KEY PLAN
NTS
TO MGS
TO BXR
TO BALARAM
HWH – NEW DELHI MAIN LINE
STPL PLANT AREA
TO MUGHAL SARAI
TO CHUNI VILLAGE
TO CHOUSA VILLAGE / MAIN ROAD
TO PLANT
TO PLANT YARD
PLANTATION
HEIGHT-9.0m (Proposed)
DETAILS OF EAI AND ESR
PROP. CHAUSA STN & PANEL BUILDING AT Km 672.14 F / HOWRAH
UP / DOWN Sidings
C.L. OF CHAUSA STN BUILDING AT Km 672.14 F / HOWRAH
C.L. OF BRIDGE No-366 (3X12.2m+4")
C.L. OF BRIDGE No-365 (1X6.1m+4")
PT. CH: 780.73 FICSB (1+4"L)
PT. CH: 716.607 FICSB (3+4"L)
PT. CH: 703.937 FICSB (1+4"L)
BOUNDARY WALL
PASSENGER FOB
EXISTING LONG CH: 1095.4m FICSB
EXISTING LONG CH: 1095.4m FICSB (TO BE DISMANTLED)
BR. No. 2 CH:640.00m 1 X 2.5m R.C.C Box
L-XING CH: 181.0m P/GB GOOMTY TT-2-T-2 TA/H/8347 At Km 672.5-3 27.5.17
L-XING DETAILS BETWEEN CSA-GMR
L-XING DETAILS BETWEEN BXR-CSA
LEGEND
CONTINUED TO SHEET-NO.2
CONTINUED FROM SHEET-1
CONTINUED TO SHEET NO.3
ALT-I
AUTHORITY OF WORK:- CRS's LETTER NO CRS/ECR/DNR/CSA/LC-INT/21/1328,DATED:10.01.2022

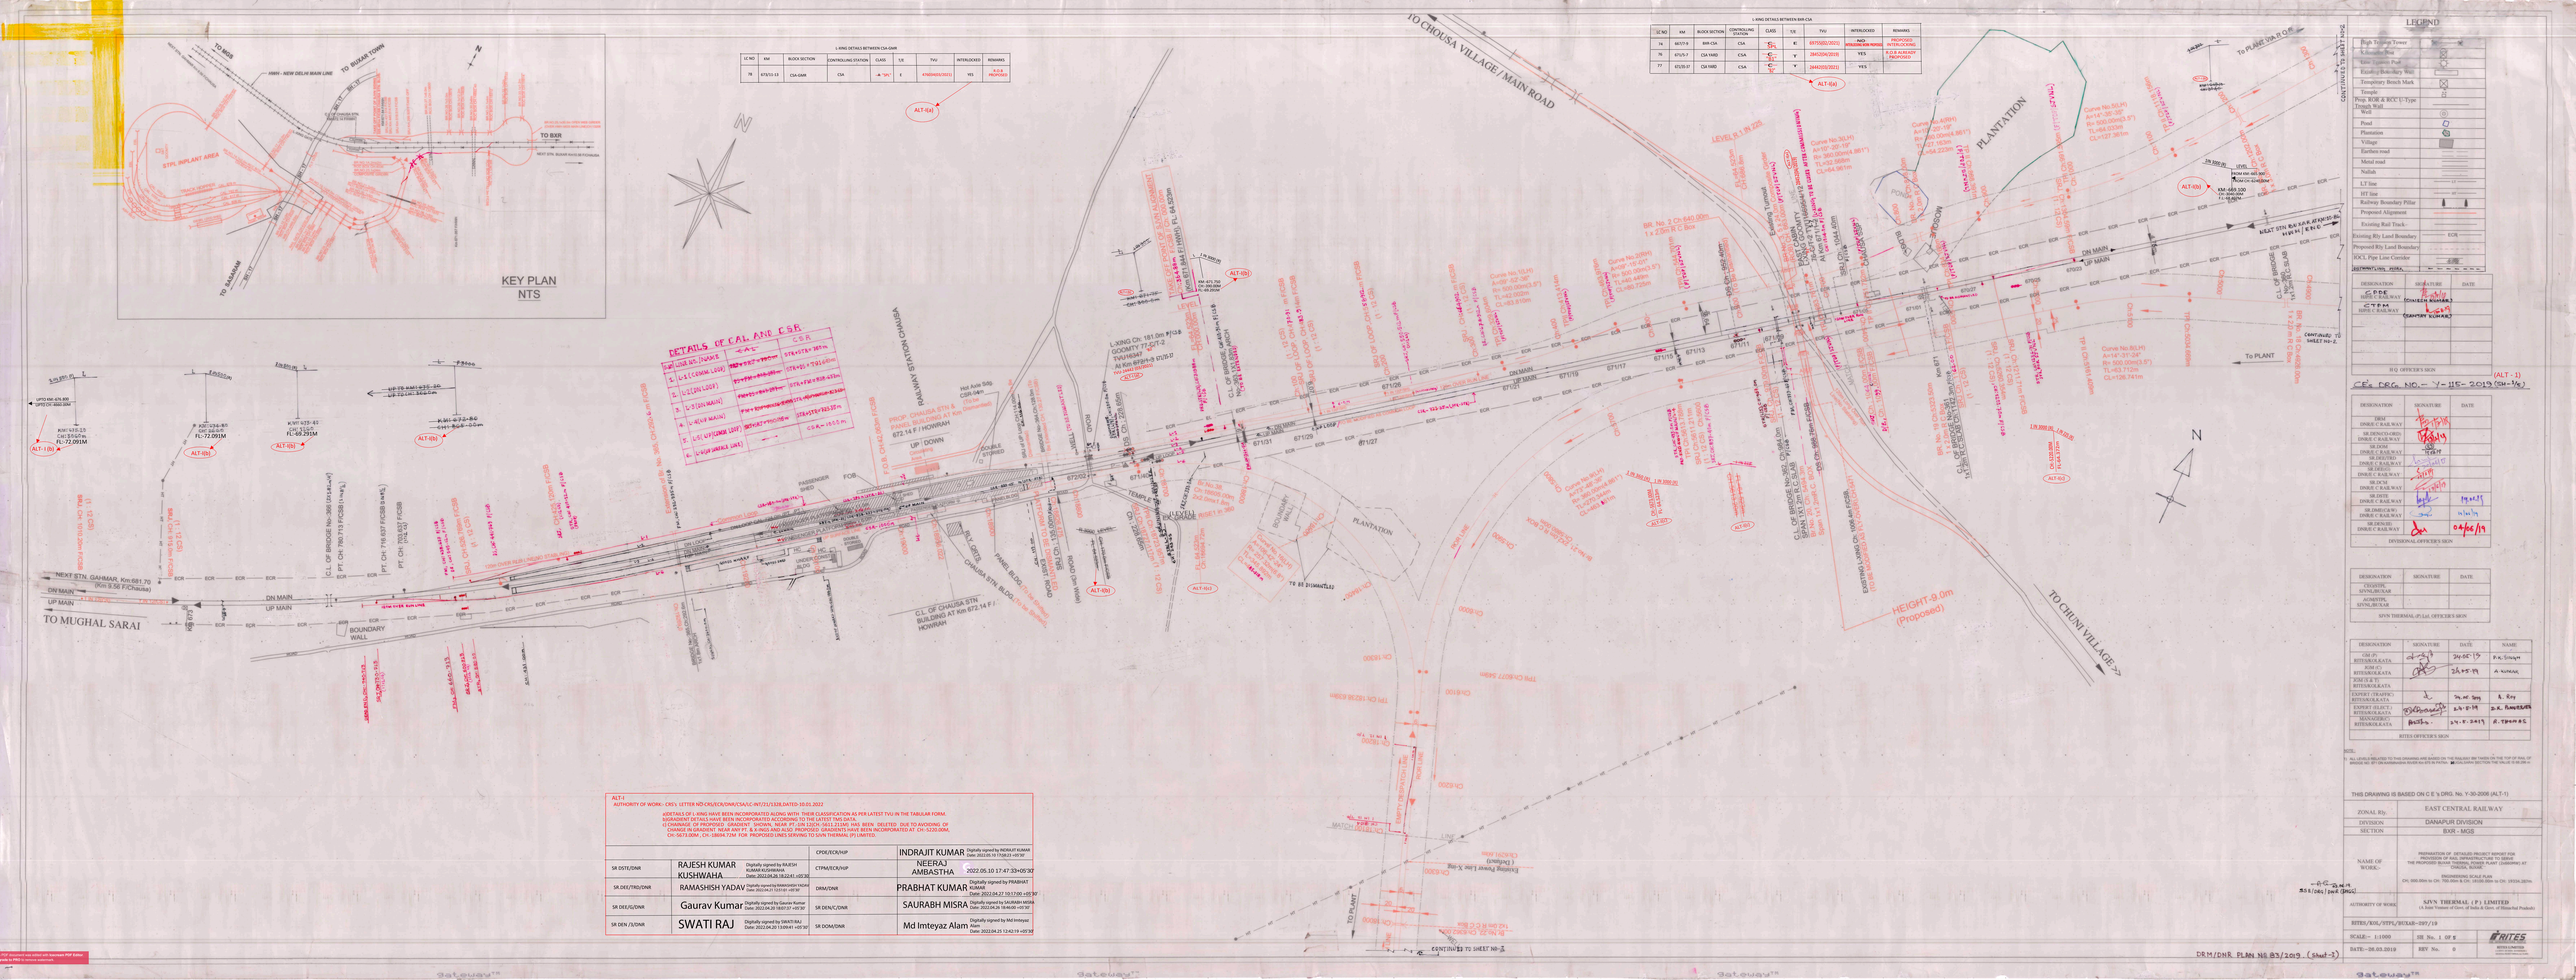
#DETAILS OF L-XING HAVE BEEN INCORPORATED ALONG WITH THEIR CLASSIFICATION AS PER LATEST TVU IN THE TABULAR FORM.
#L-XING CH: 181.0m P/GB GOOMTY TT-2-T-2 TA/H/8347 At Km 672.5-3 27.5.17

#1) CHAINAGE OF PROPOSED GRADIENT SHOWN, NEAR PT.CH:1325/4-1421.21(M) HAS BEEN DELITED DUE TO AVOIDING OF CHANGE IN GRADIENT NEAR ANY PT, & X-INGS AND ALSO PROPOSED GRADIENTS HAVE BEEN INCORPORATED AT CH:-5220.00M, CH:-5673.00M , CH:-1804.73M FOR PROPOSED LINES SERVING TO SIVN THERMAL (P) LIMITED.
DRM/DNR PLAN NO 83/2019 (Sheet-2)
